# UNITED STATES PATENT AND TRADEMARK OFFICE

APPLICATION NO.	FILING DATE	FIRST NAMED INVENTOR	ATTORNEY DOCKET NO.	CONFIRMATION NO.
10/761,638	01/21/2004	Brad Menzies	65,748-865	3342

**Office Action Summary**

# **ATTACHMENT 1**

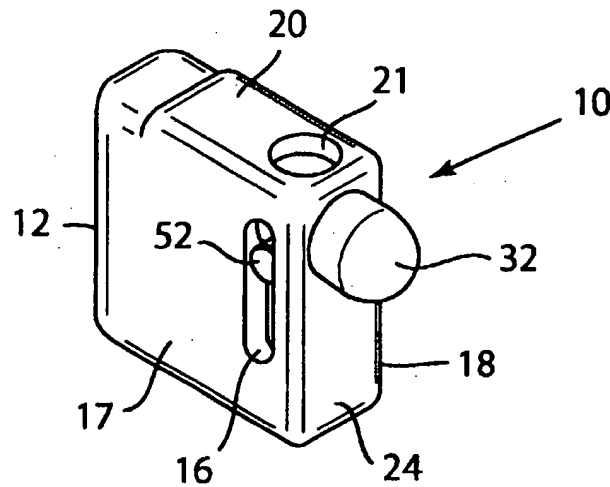
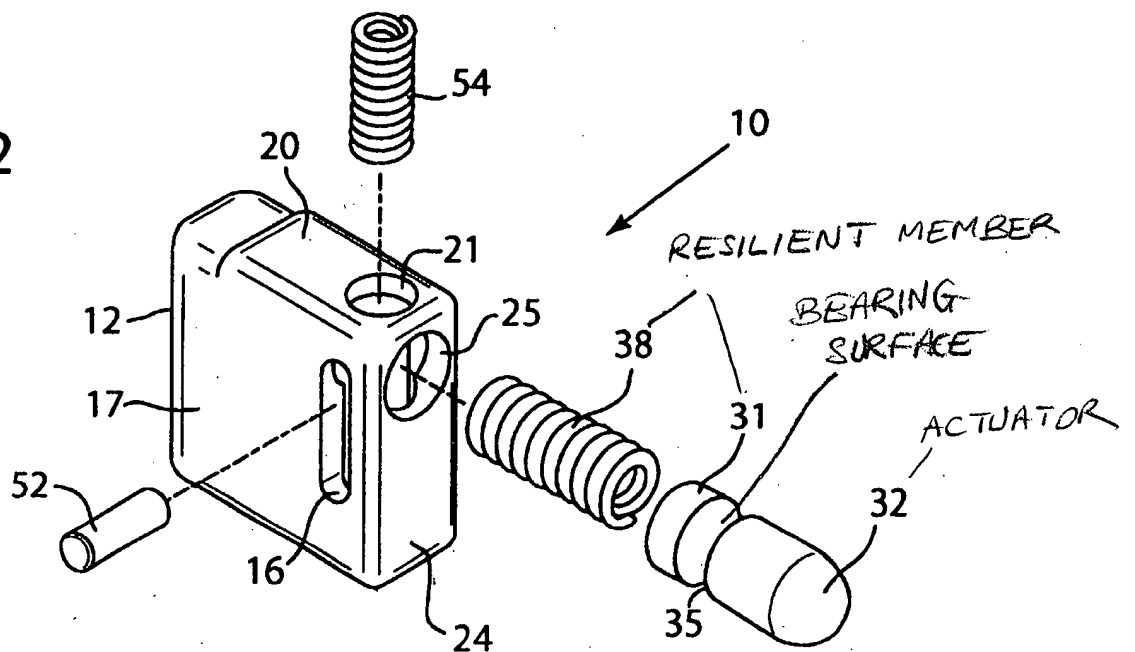
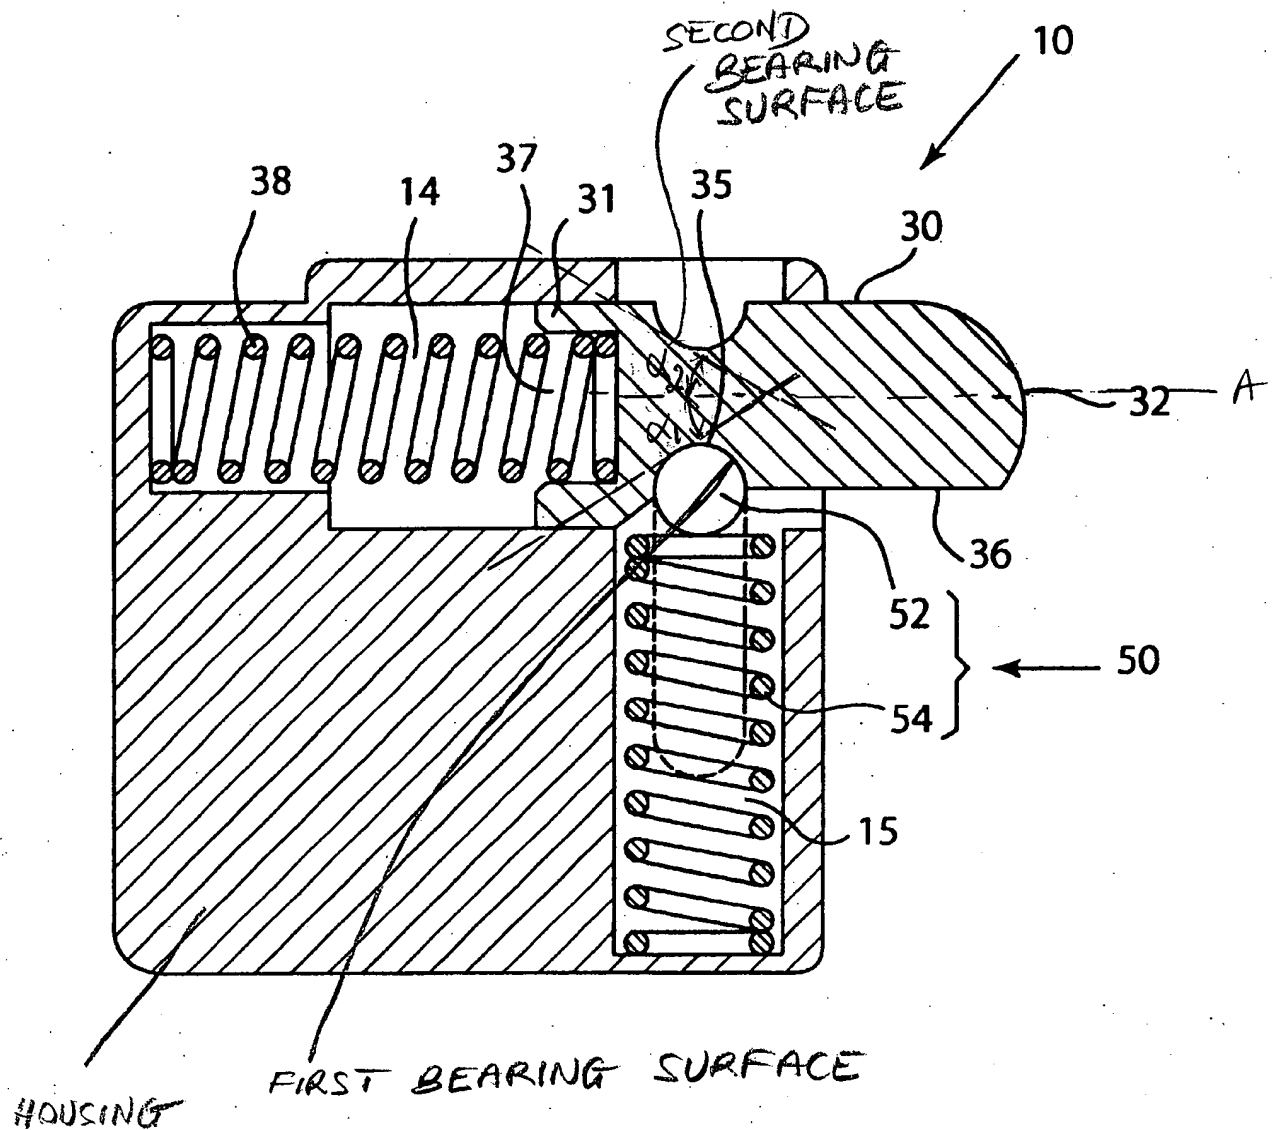
a resilient member (38, 31, Fig. 2) presenting a bearing surface (35) movable within said chamber (14) along an operational axis (A, see Attachment 1, hereinafter "Att. 1"),

an actuator (32) engaging said detent member (52) for moving said detent member (52) from said initial position to said plurality of active positions when engaged by the pedal arm, said assembly characterized by said bearing surface (35) being disposed at an acute angle ( $\alpha_1$ . See Att. 1) to said operational axis (A) to urge said detent member (52) back to said

Claim 1 is anticipated by Lewis because Lewis teaches each claimed element in the claim. Note that claim 1 does not specifically recite any shape of the bearing surface. Therefore, Lewis's angle defined by a tangent of Lewis' arcuate bearing surface and the operational axis "reads on" the claimed angle.

Regarding claim 4, said resilient member (38, 31) presents a second bearing surface (Att. 1) positioned at a second acute angle ( $\alpha_2$ . See Att. 1) to said operational axis (A).

Regarding claims 2 and 3, Lewis's acute angle ( $\alpha_1$ . See Att. 1) is of a determined degree as seen in Fig. 3.

# **ATTACHMENT 2**

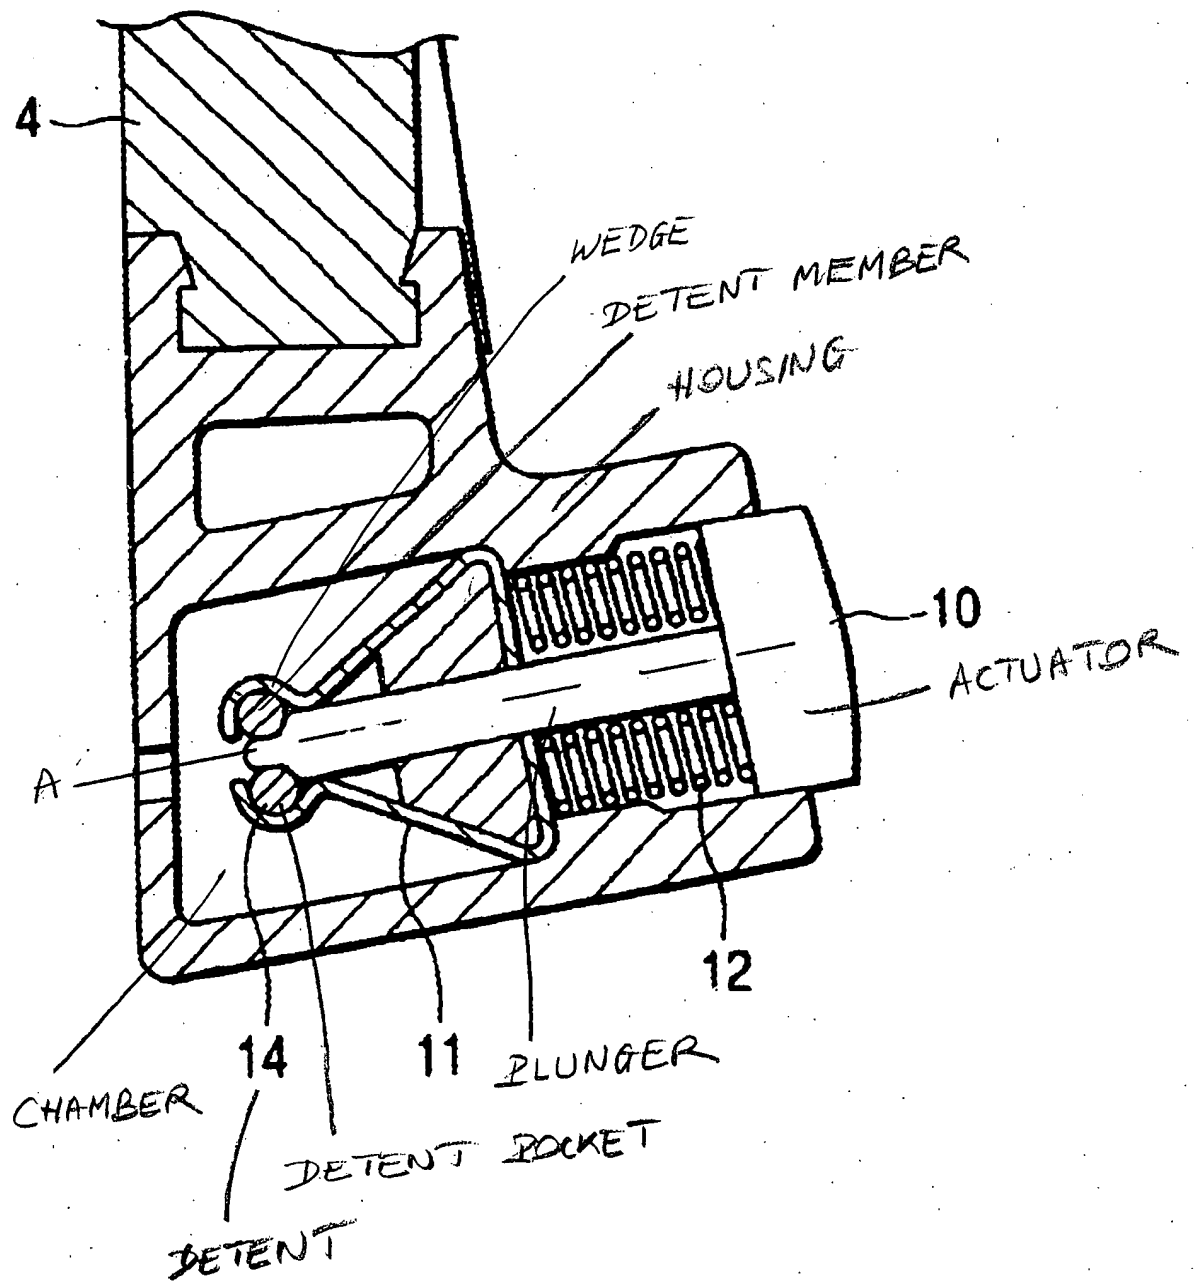
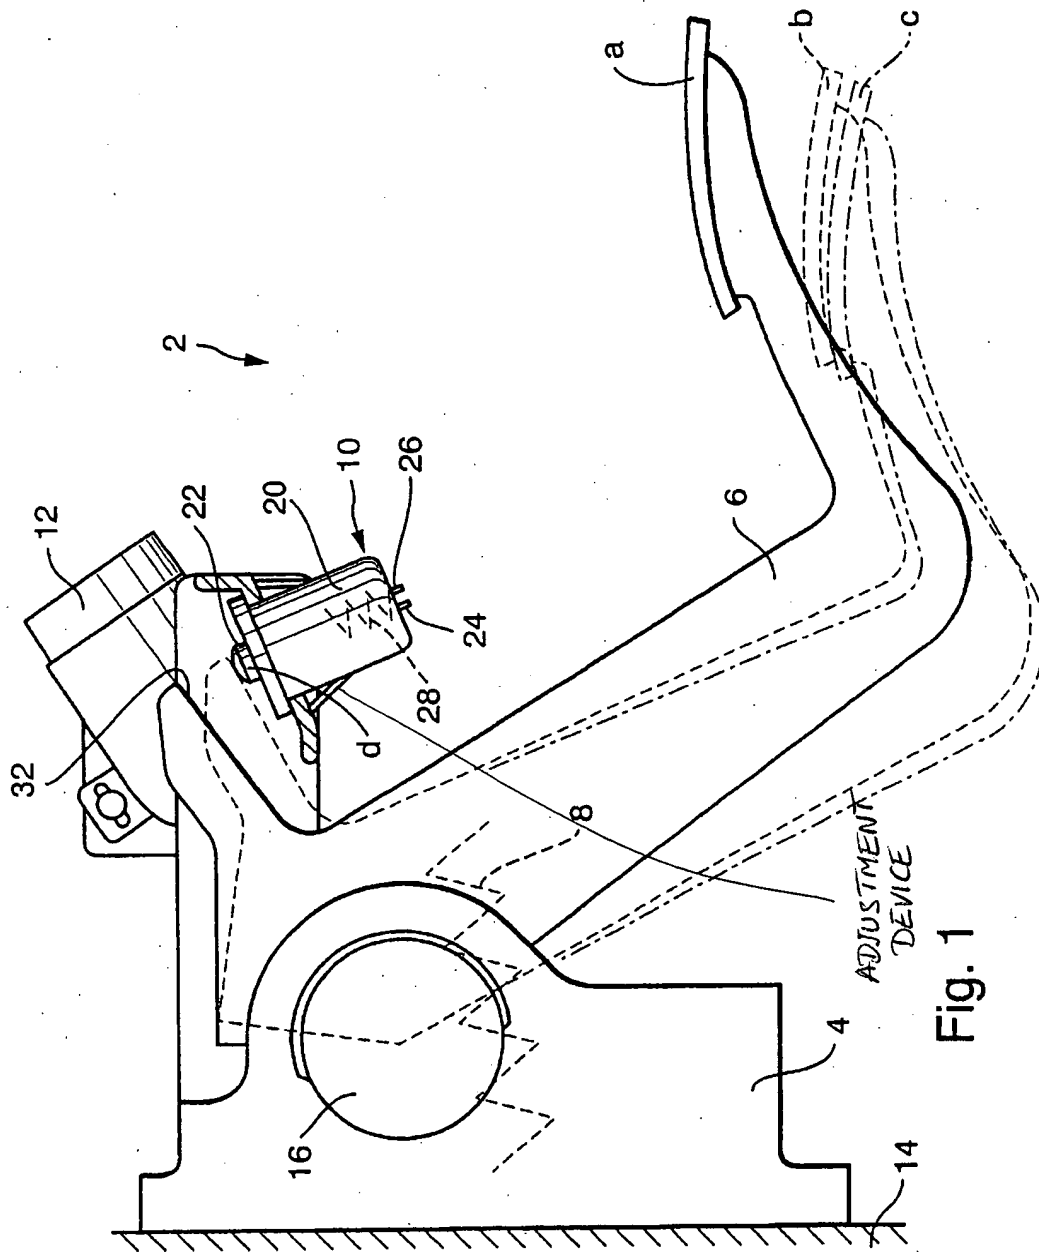
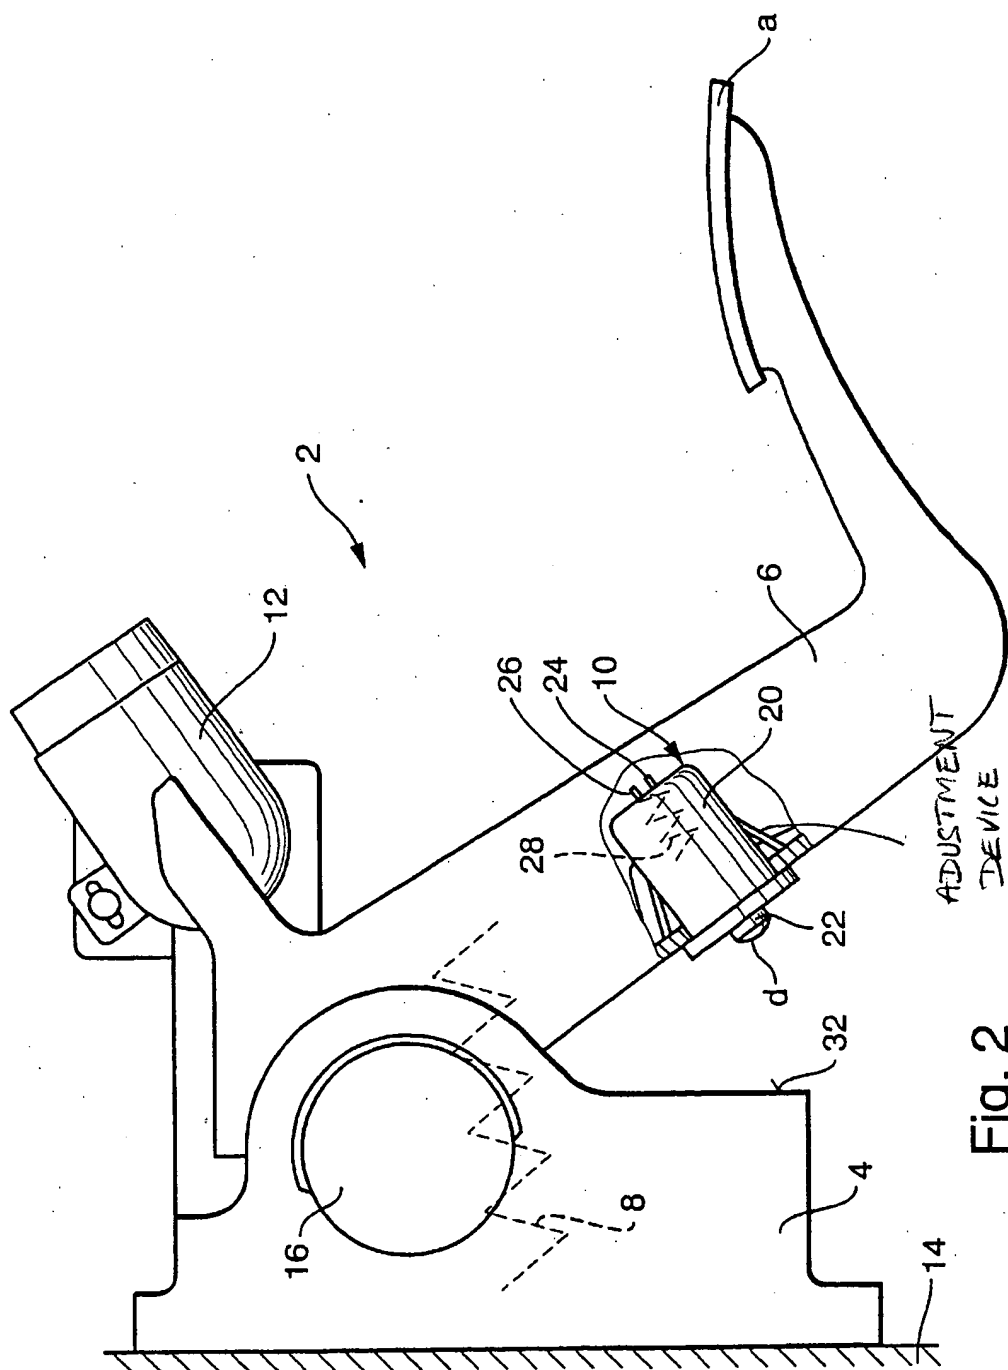
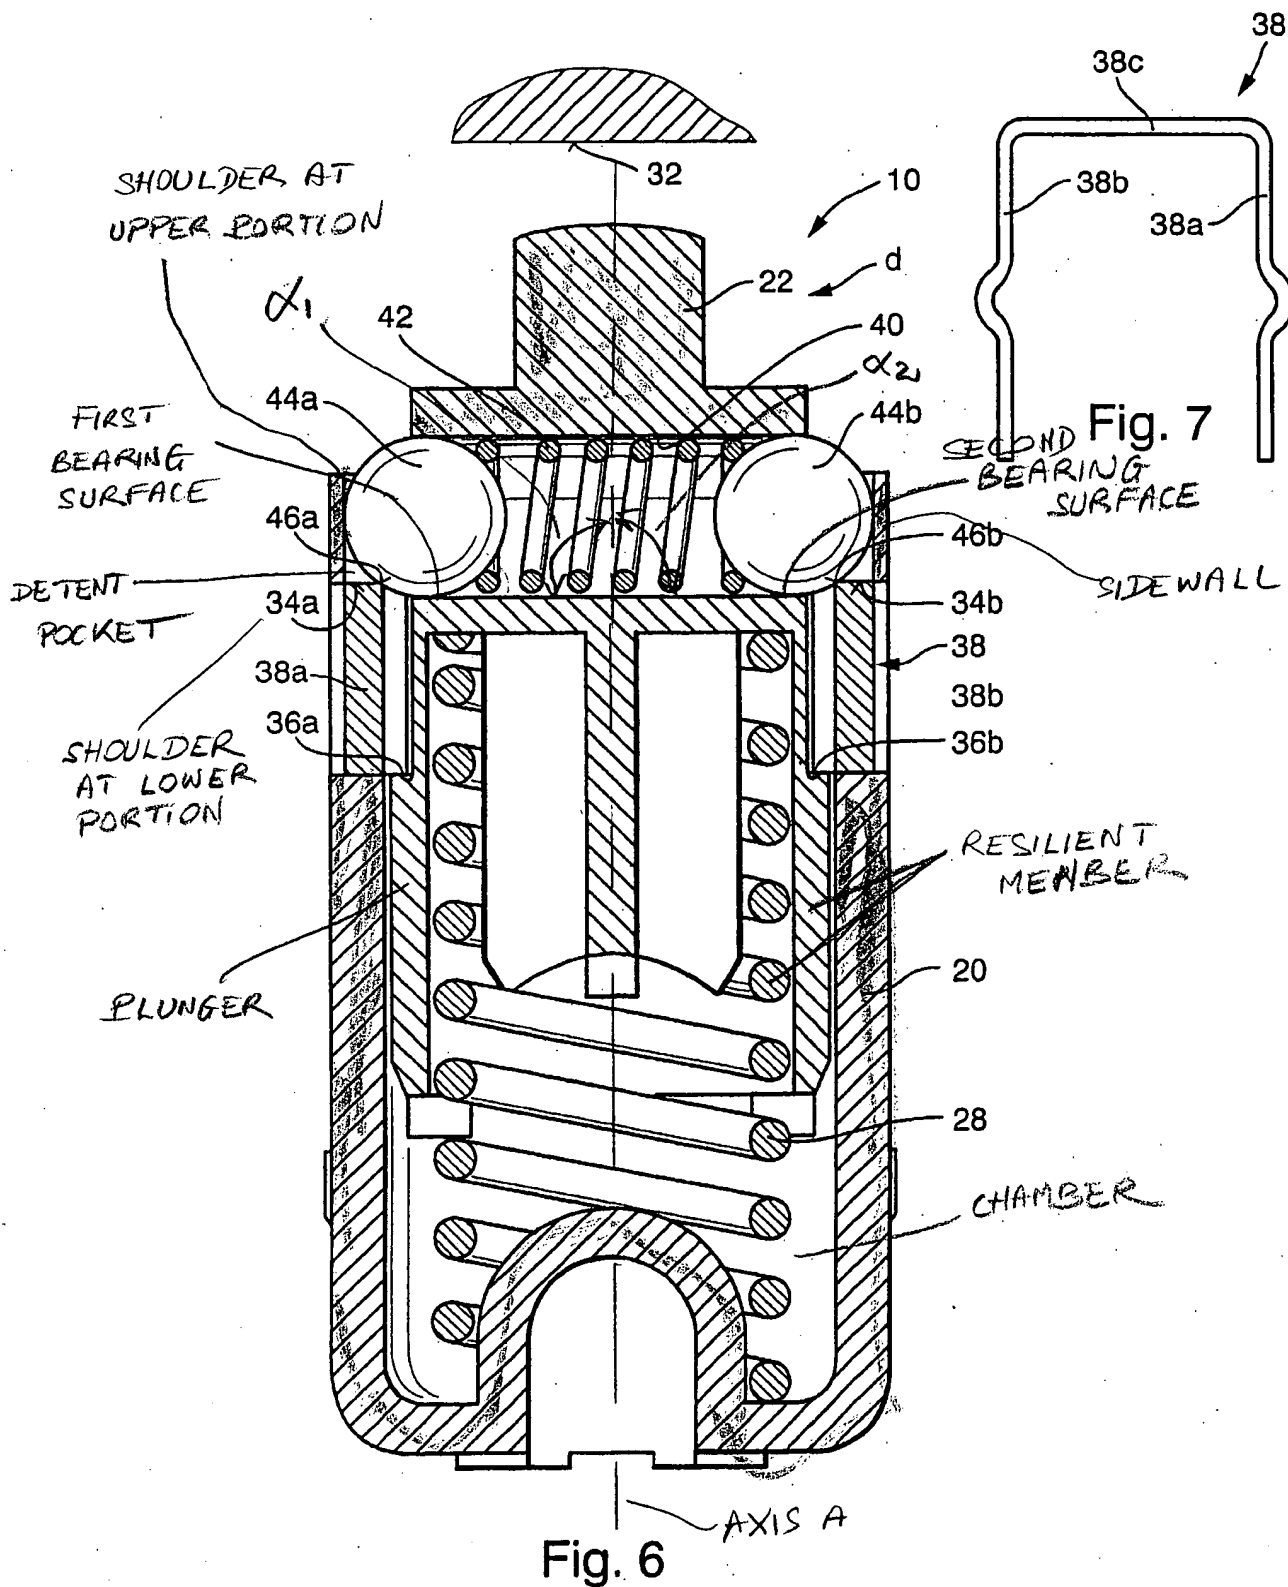
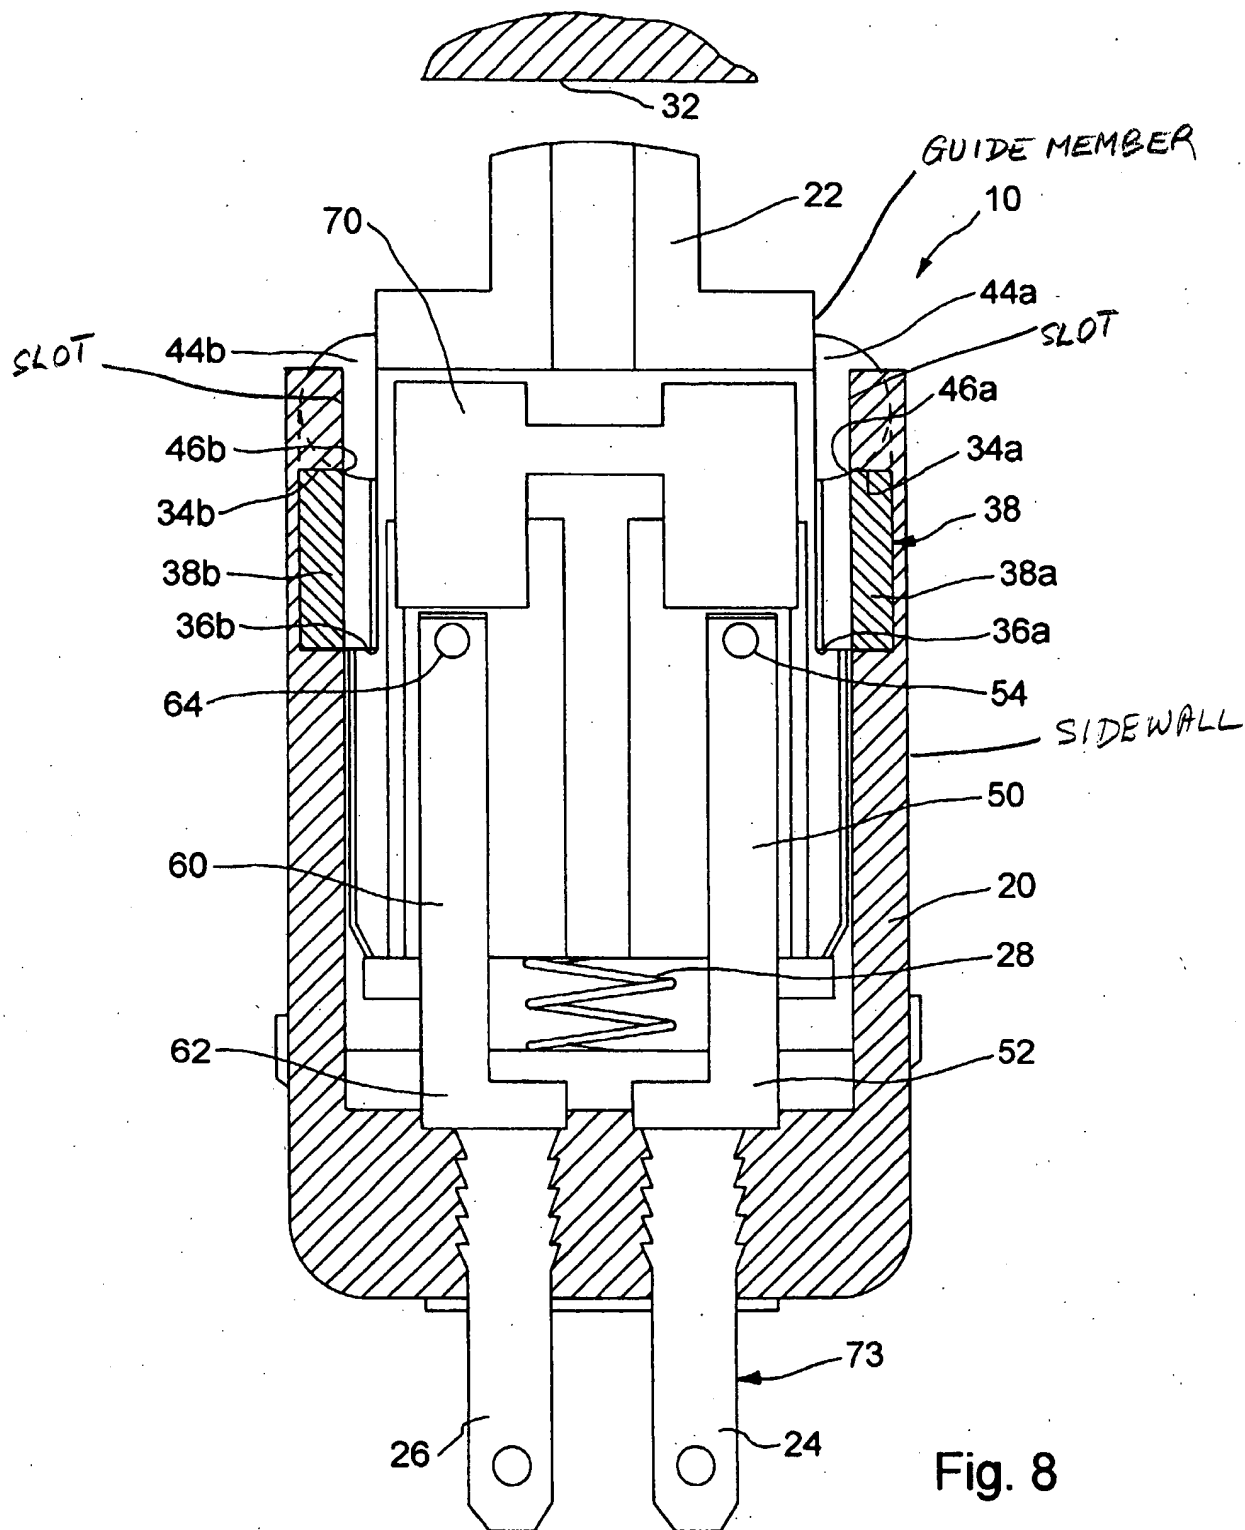
a housing (20) defining a chamber (Attachment 2, hereinafter "Att. 2"),

a resilient member (28, Att. 2) presenting a bearing surface (Att. 2) movable within said chamber (Att. 2) along an operational axis (Att. 2),

an actuator (22) engaging said detent member (44a) for moving said detent member (44a) from said initial position to said plurality of active positions when engaged by the pedal arm 6, said assembly characterized by said bearing surface (Att. 2) being disposed at about 90° angle ( $\alpha_1$ . See Att.) to said operational axis (A) to urge said detent member (44a) back to said initial position under the bias of said resilient member (28, Att. 2) when the pedal arm 6 is disengaged from said actuator (22).

Marquardt teaches the invention substantially as claimed. Ibid. column 6, lines 6-64 and claims 1-36. However, Marquardt's angle is about 90° instead of 30°-60° or 45°.

Regarding claim 4, said resilient member (28, Att. 2) presents a second bearing surface (Att. 2) positioned at a second 90° angle ( $\alpha_2$ . See Att. 2) to said operational axis (A).

Regarding claim 7, said housing (20) includes a sidewall (Att. 2) and said sidewall (Att. 2) defines first and second pairs of detent pockets (at 34a and 34b in Fig. 6, Att. 2) for receiving said detent members (44a, 44b).

Regarding claim 13, said housing (20) includes a sidewall (Fig. 8, Att. 2) and a first pair of elongated slots (Att. 2) defined therein and said actuator (22) includes a first pair of guide members (Att. 2) for reciprocating within said first pair of slots (Att. 2).

Regarding claim 19, an adjustment device (i.e., a bracket in Figs. 1 and 2. See Att. 2) for adjusting a position of the kickdown mechanism 10 relative to the pedal arm 6 (see two different positions of the kickdown 10 in Figs. 1 and 2) to synchronize movement of the detent members (44a, 44b) out from the detent pockets (Att. 2) with generation of the control signal at a predetermined magnitude.
